WEEKS MARINE INC.**WMI Job No. 2010-0148****REQUEST FOR INFORMATION (RFI) NO. 002****CONTRACT NO. B000964.001**

ARCADIS RFI number: 003,
Weeks RFI No 002

SECTIONS
SHEET 2 OF 3
STRUCTURAL

2011-05-12-SK1-a
MAY 12, 2011
REF S-2 ARCADIS DWGS

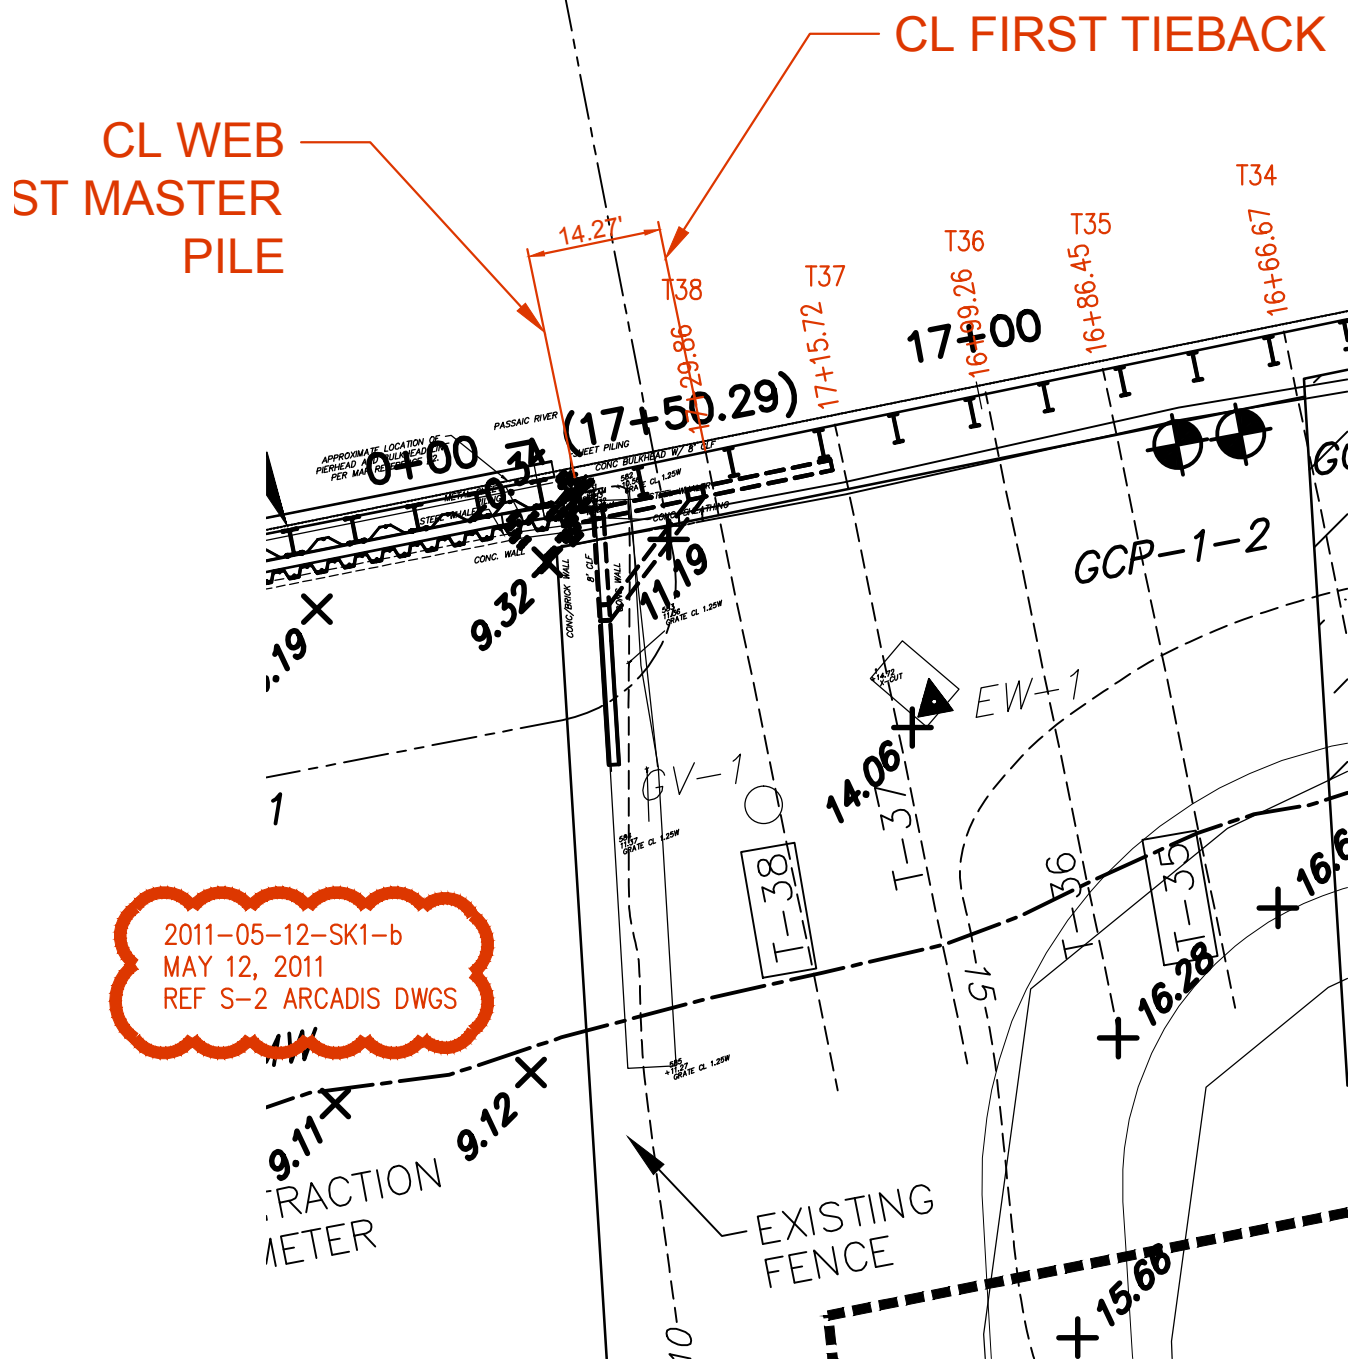
Could you give me the exact location of the first and last tie back in relation with the existing king piles? Thanks Claude

I have attached a sketch showing the tiebacks and master piles. Take a look and see if this answers all the questions.

FOR APPROVAL
5-20-11

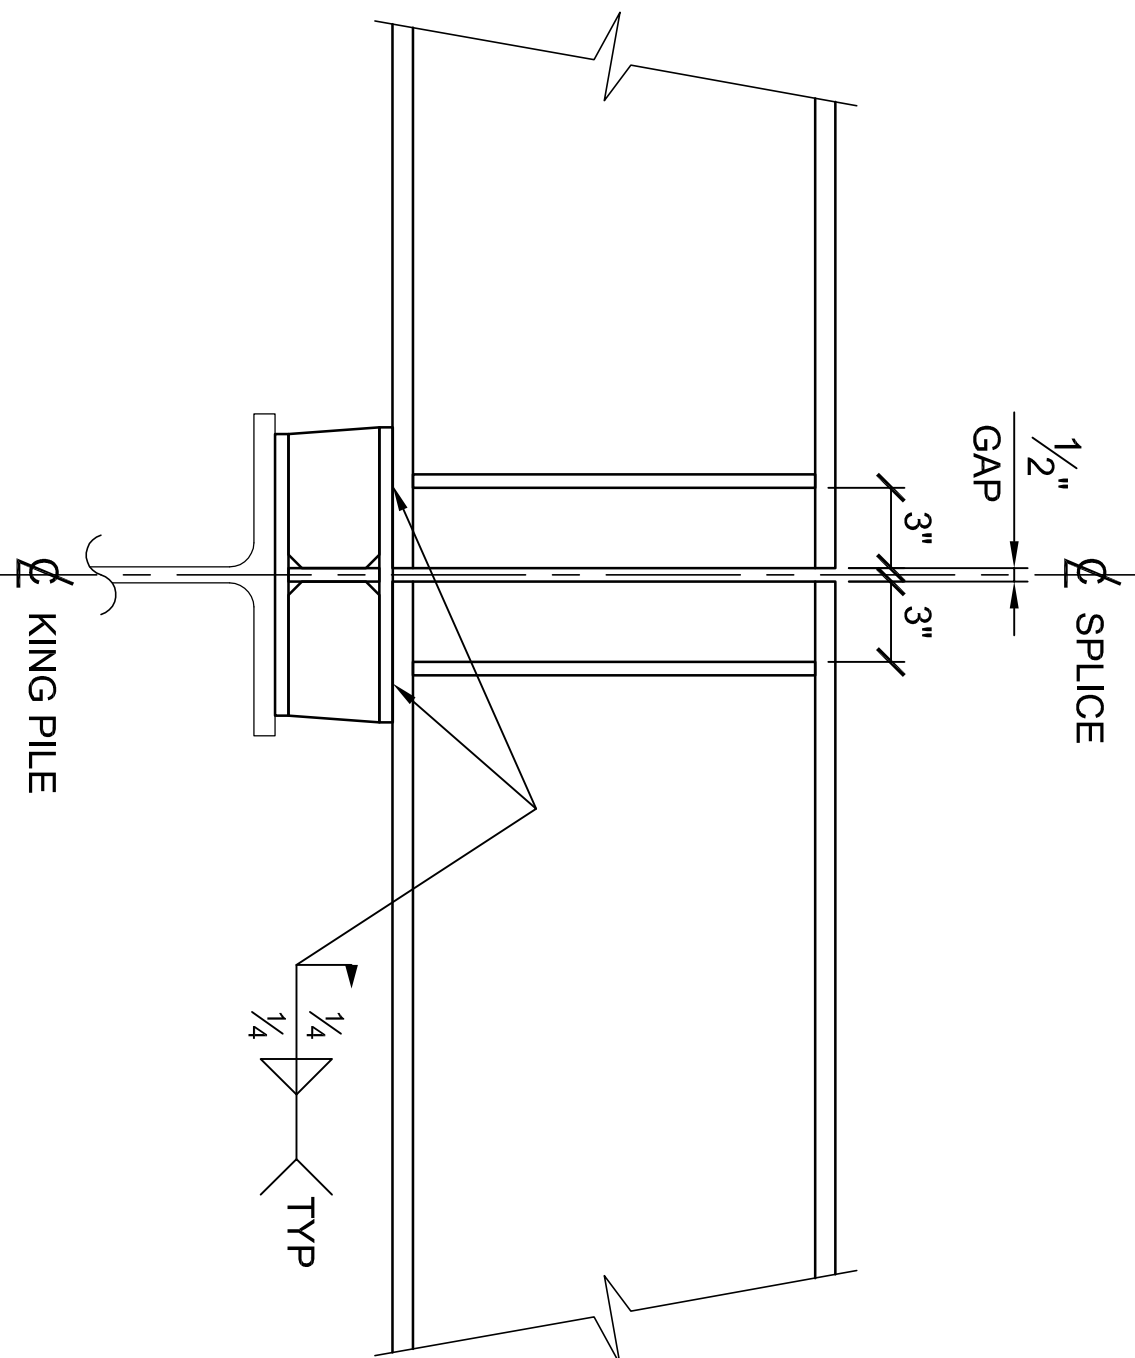
We have revised our shop drawing based on the detail received earlier for the W16X77 wale at OU-1 Floodwall. Attached is RFI 02 regarding the master pile at each extremity of OU-1 Floodwall.

Please provide final dimension of the W16x77 and how you would like us to proceed at each extremity of OU-1 Floodwall.

The attached drawing shows the location of the existing Tie-Backs and new Tie-Backs. The new Tie backs 1 and 38 are outside the existing Tie-Backs. The subsequent master piles are behind the concrete wall and sheet pile. Please confirm if the connector, as shown on drawing S-17, can be weld to the sheet piles since the exact location of the master piles cannot be determinate in the field. Also confirm the length of the wale 16 x 77 at each extremity.

3. Existing concrete and AS-500 sheet steel will need to be removed in order to install the supports. Please refer to detail 2 on sheet S-17.
4. As Built information surveyed by French & Parrello Assoc. during construction (7/18/2000) locate the piles in plan and elevation (Ref: Attachment 2 of Appendix K report by BBL).

5. Master Pile 2 is located 9.91 feet to the west of Master Pile 3. Per detail 3, on drawing S-17, the W16x77 wales must extend 1'-0" beyond Master Pile 2.

6. Master Pile 73 is located east of Master Pile 72 by 9.89 feet. Per detail 3, on drawing S-17, the W16x77 wales must extend 1'-0" beyond Master Pile 73.

FIGURE
V2

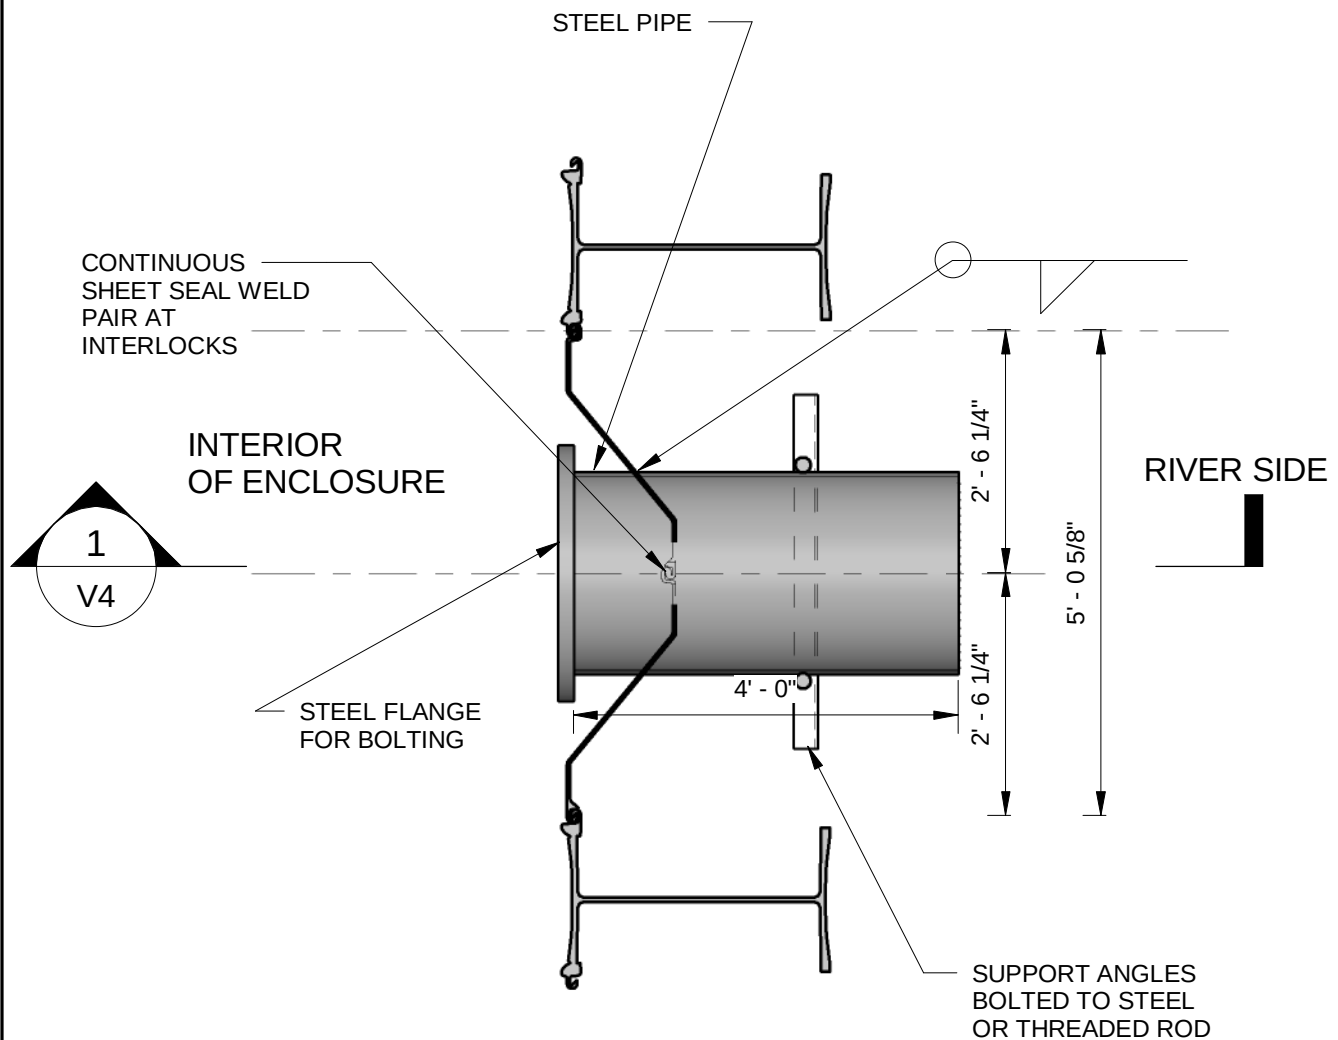
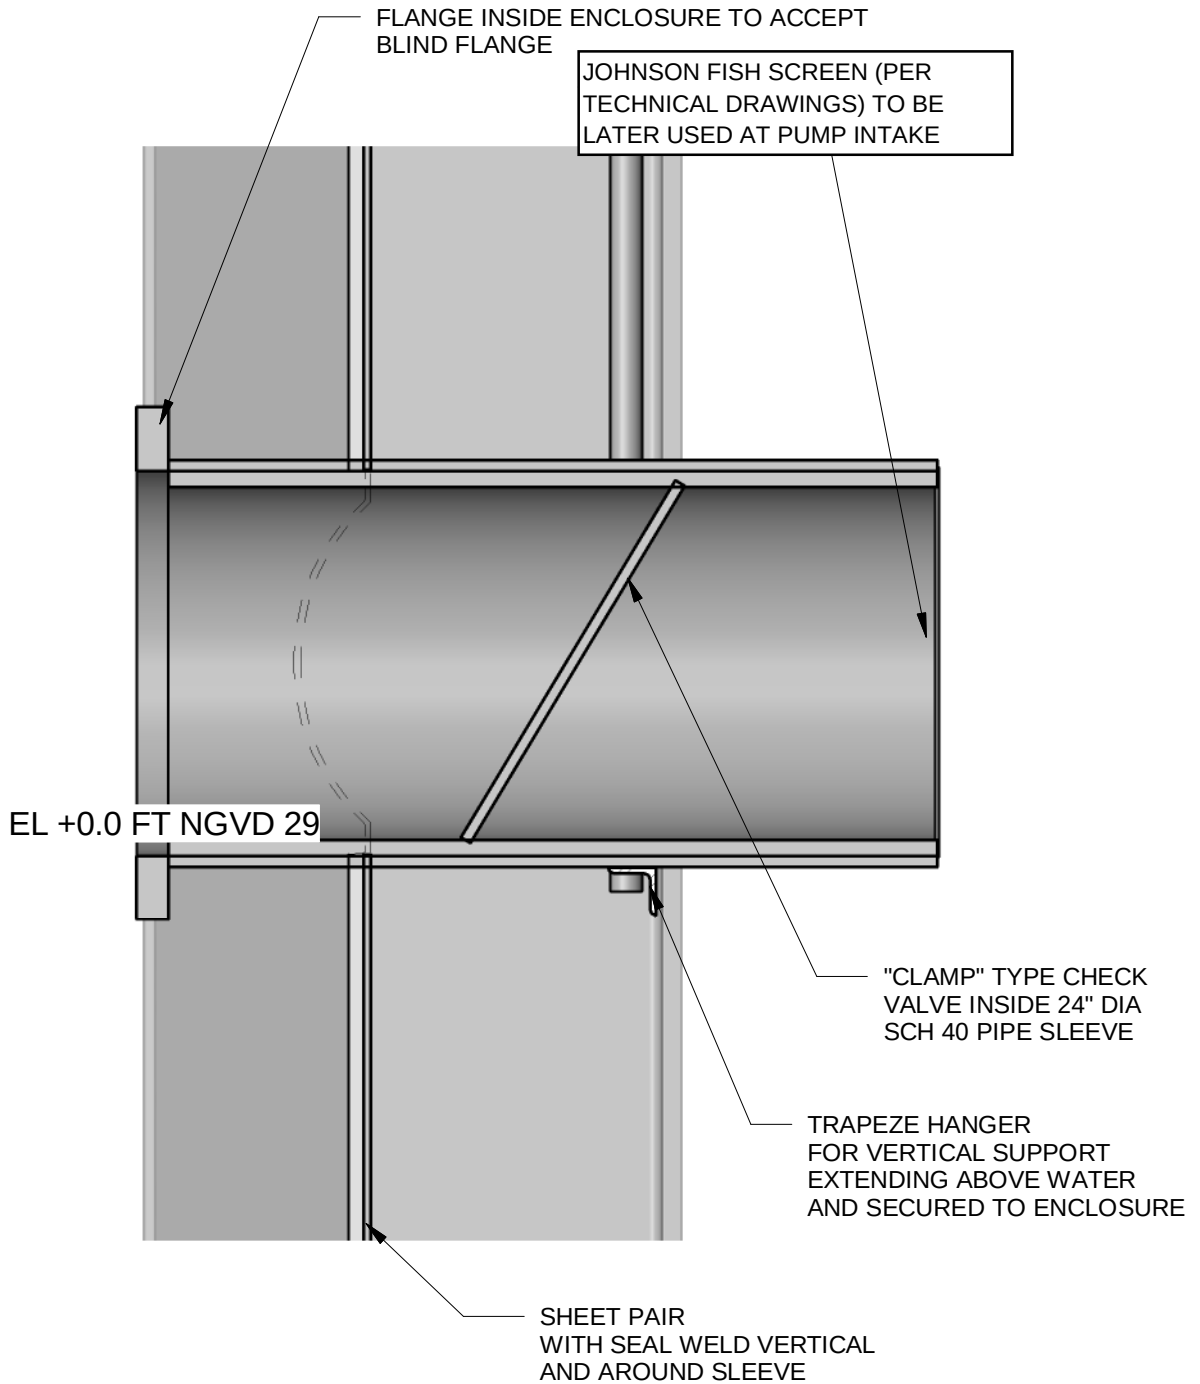
Arcadis requested that Weeks provide a method to maintain the water elevation in the enclosure at an elevation +5 without having to use submersible pumps during the winter. Following discussions on this matter, it was decided that a one way valve would be installed on the enclosure. Please provide a drawing identifying the location where the one way valve will be installed. The valve will be installed prior to driving the sheet pile, therefore; L&L Fabrication should be contacted by Arcadis.

Regarding RFI-006, please find attached vendor information and sketches for one-way valve. The valve is a 24-inch diameter clamp style inline check-valve by Tideflex. Modifications to the detailing shown in sketches may be possible to better facilitate construction (coordinate with ARCADIS to finalize detailing).

Reference: S-17 Detail 4

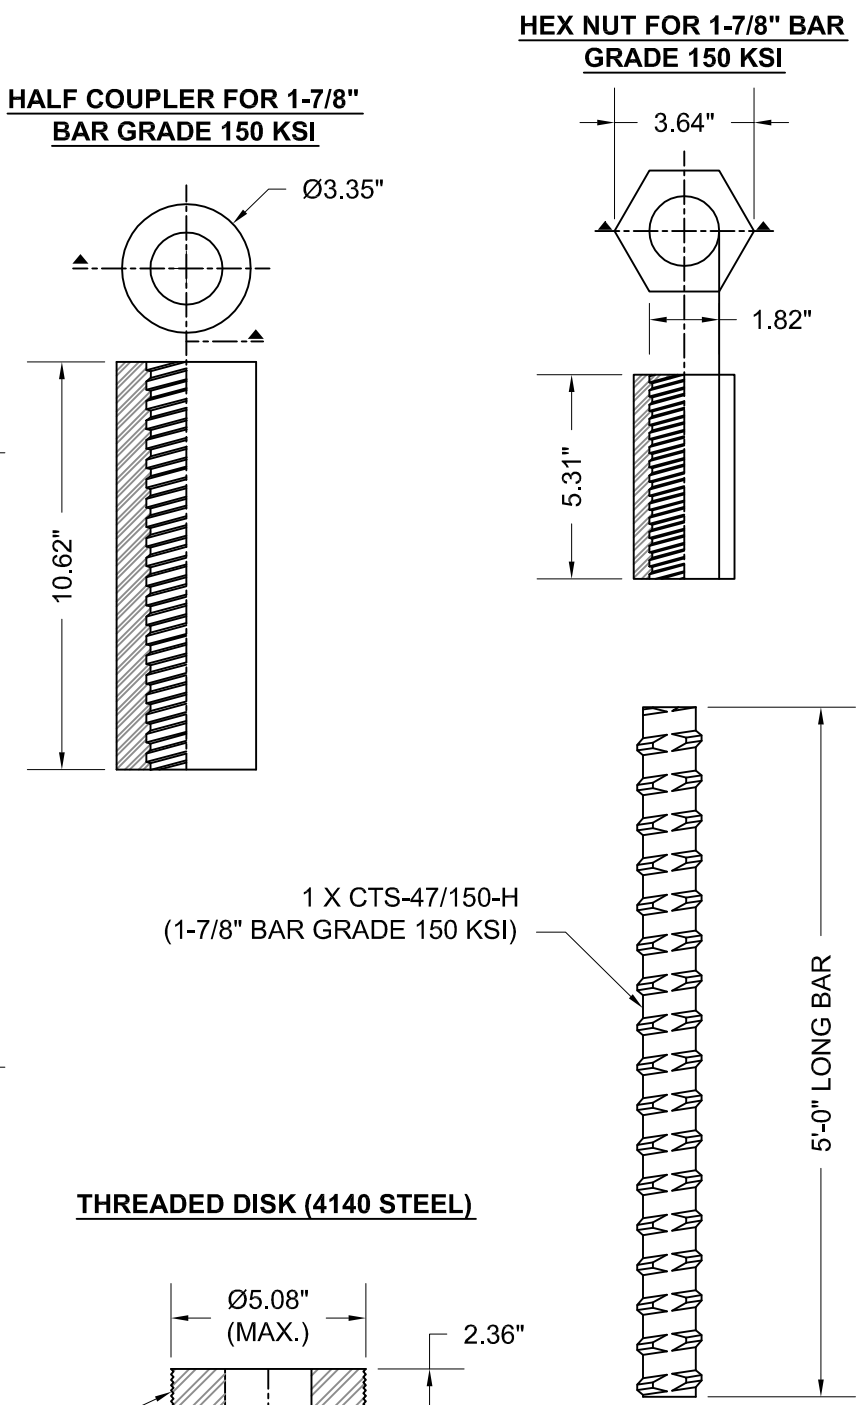
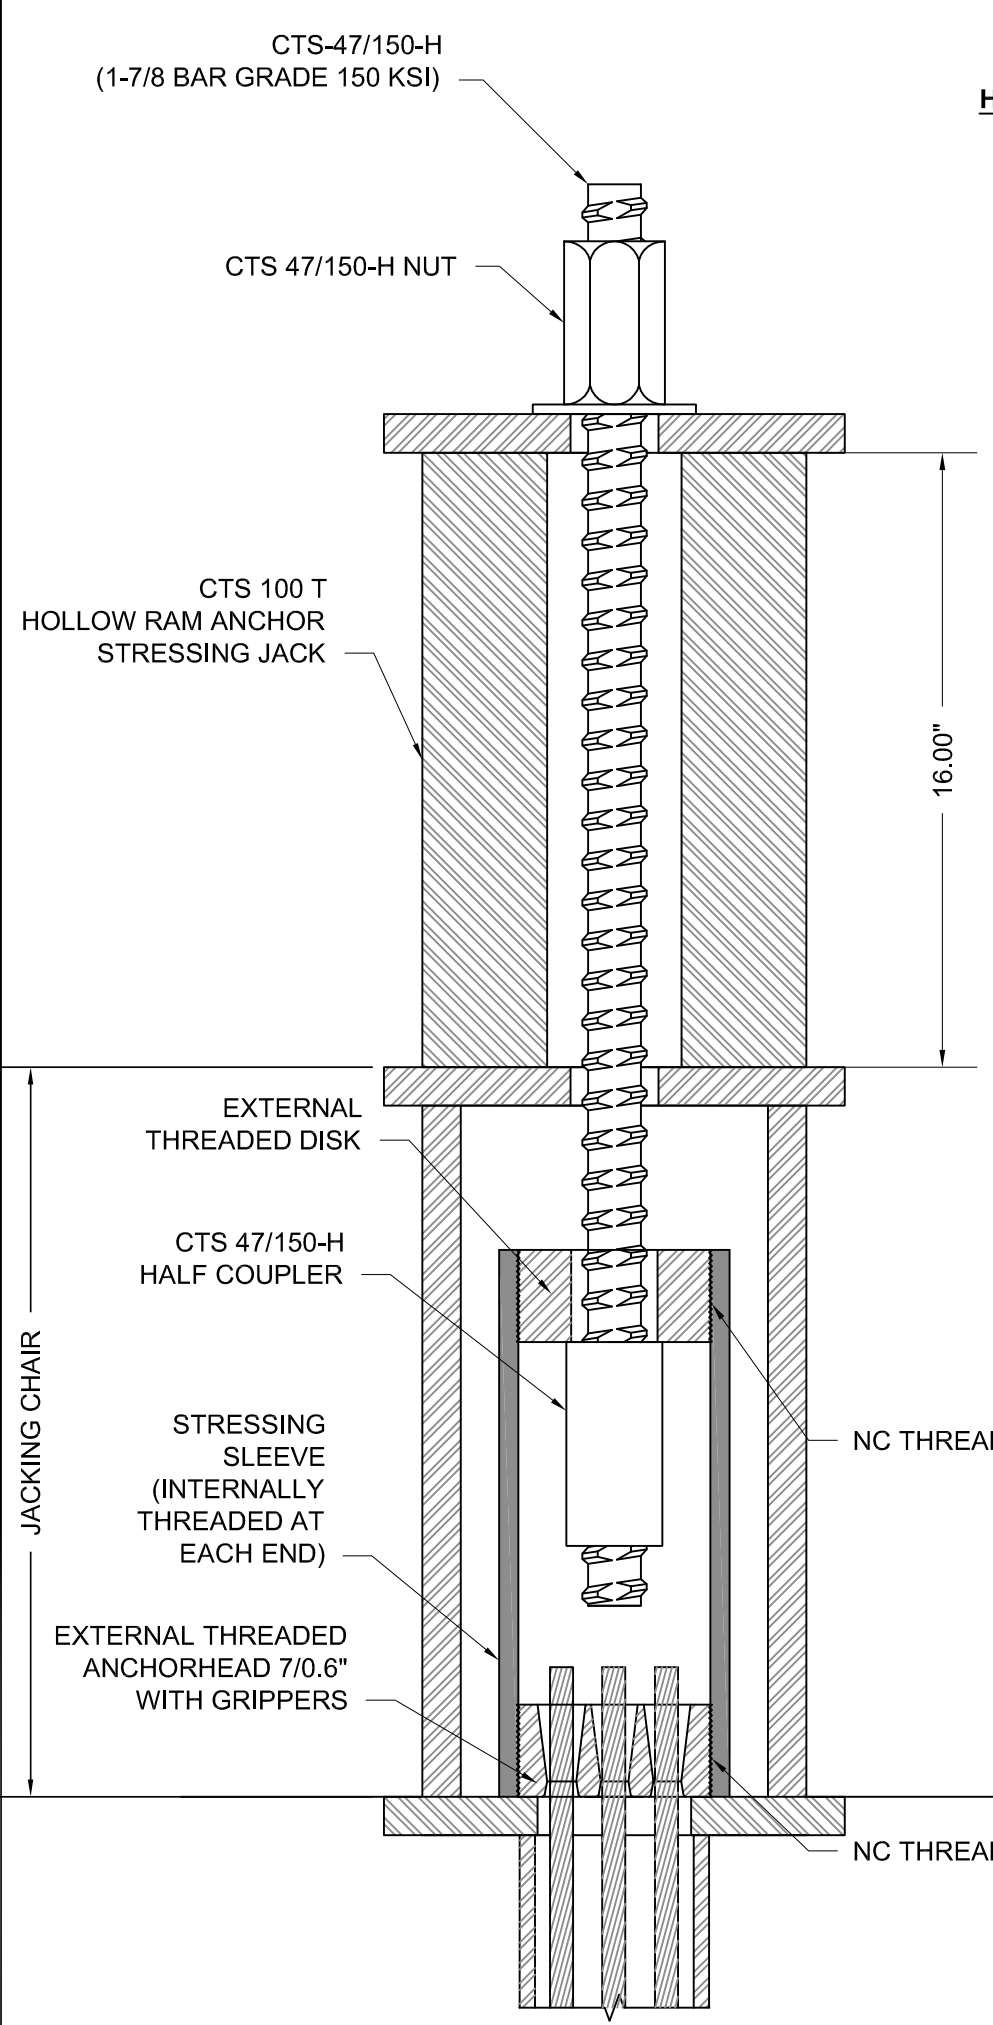
Detail for the termination of the strands on the contract drawing shows to be final. Nicholson will terminate all strands as shown in the contract drawing unless directed otherwise. Note that if called as current drawing details strands can be released to zero load but not either increased or reduced by selected amounts in response to either pile or load cell readings. Please provide additional information on how Arcadis intent to temporarily call the installed strands if necessary and when stressing will be completed.

Claude/Coleman, as mentioned yesterday, ARCADIS has reviewed and is good with the attached details for tieback termination. Please let me know if there are any questions/comments.
